**ATTACHMENTS TO REPORTS OF THE BLAYNEY SHIRE COUNCIL
MEETING
HELD ON TUESDAY 24 FEBRUARY 2026**

27	DA 2025/0007 Alterations and Additions to Hotel at 29 Park Street Millthorpe (Commercial Hotel)	
	Attachment 1: Draft Conditions of Consent.....	1
	Attachment 2: Description of Proposed Amendment.....	5
	Attachment 3: BCA Assessment Report.....	7
	Attachment 4: Access Report.....	45
	Attachment 5: Architectural Plans	65
	Attachment 6: Submission 1.....	73
	Attachment 7: Submission 2	75

**DA 2025/0007 – 29 Park Street, Millthorpe
Heritage advice, proposed development, former Commercial Hotel**

Project	Commercial Hotel Site, 29 Park Street Millthorpe
Report	BCA Assessment Report (BCA 2022)
Reference	240716-BCA DA Report-r3
Date	24/10/2025
Client	Kunghurloo Pty Ltd
Phone	0427 020 557
Email	Amanda.watts@mail.com

Title
GROUND FLOOR PLAN
Date: 24 September 2025

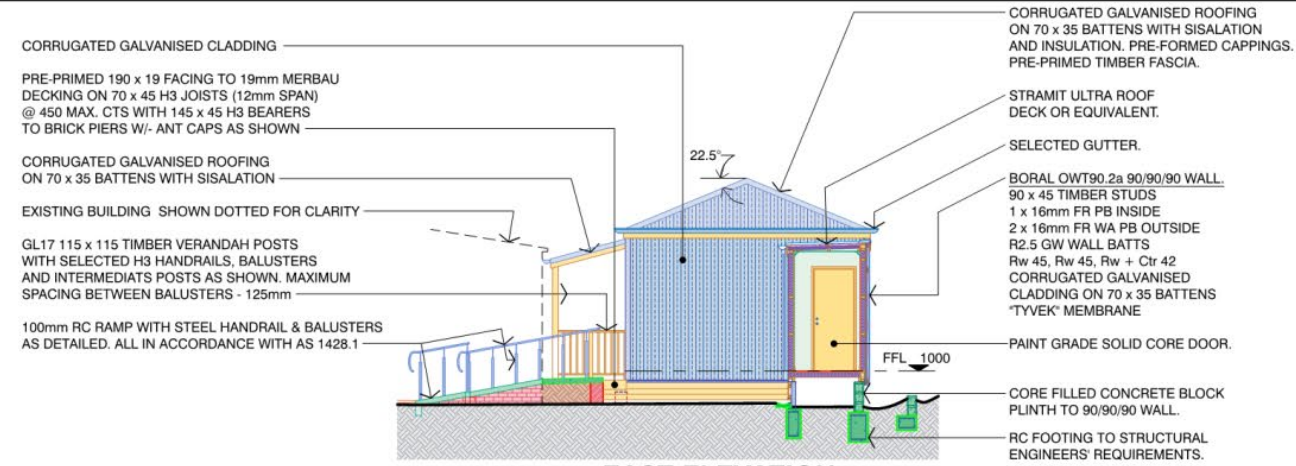
The drawings show a portion of the western wall within 1.5 m of the northern boundary. This wall and openings are required to be protected.

Natural light to Room 1 is to be from a dormer window but no further detail has been provided for assessment.
